Technical BULLETIN

2003 RX10MH/MSH (RX-1 Mountain) Loose Rear Suspension Mounting Bracket Rivets

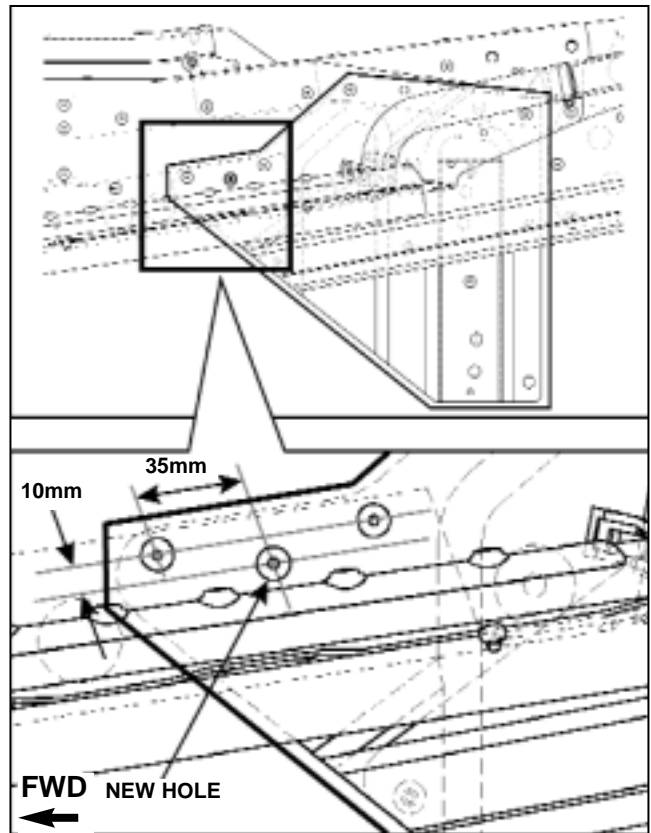
1. Remove the 4 bolts securing the rear bumper cover. Remove the bumper cover.
2. To prevent damage to the running-board traction strip area of the tunnel, perform steps 3 and 4 from the inside of the tunnel. To improve access to this area:
 - Loosen the rear axle.
 - Loosen the track.
 - Loosen the control rod bolts.
 - Elevate the rear of the snowmobile and remove the rear suspension mounting bolts and drop the rear suspension.

3. On the inside of the tunnel, use a piece of masking tape and draw a line 10mm below the two front rivet centers. Then, measure back 35mm from the front rivet center and mark the center for the drill hole location for the new front mounting bolt (refer to the following illustration for the proper location). Repeat this step on the other side.

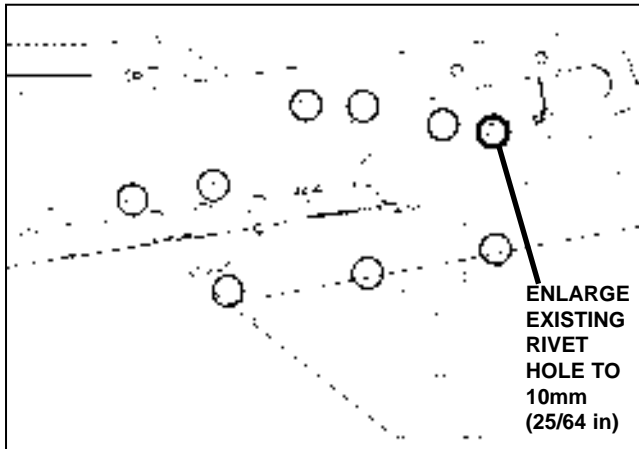
4. Drill a small pilot hole on both sides. Then, use a 10mm (25/64 in.) drill bit to complete the drilling of the new holes.

- Drill out the rear existing rivet as indicated in the below illustration on both sides. Use a 10mm (25/64") drill bit to enlarge the holes.

- Install a bolt and washer in the front holes on both sides. Install a nut on the inside of the tunnel and tighten to 4.5 m-kg (32.5 ft-lb).
- Install a bolt in the rear hole on both sides. Install a nut on the inside of the tunnel and tighten to 4.5 m-kg (32.5 ft-lb).
- If the unit has been ridden: Inspect the 16 rivets that are used to secure the rear suspension mounting brackets. Replace any loose or missing rivets with rivets supplied in the kit.
- Re-install the rear suspension bolts with blue 242 Loctite® and torque to 7.2 m-kg (52 ft-lb). Retighten the control rod bolts with blue 242 Loctite® and torque to 3.2 m-kg (23 ft-lb). Re-adjust the track tension to 25~30mm at 10kg (0.98~1.18 in. at 22 lb).
- Re-install the rear bumper cover and mounting bolts.
- Be sure the suspension is adjusted properly for the rider and riding conditions.
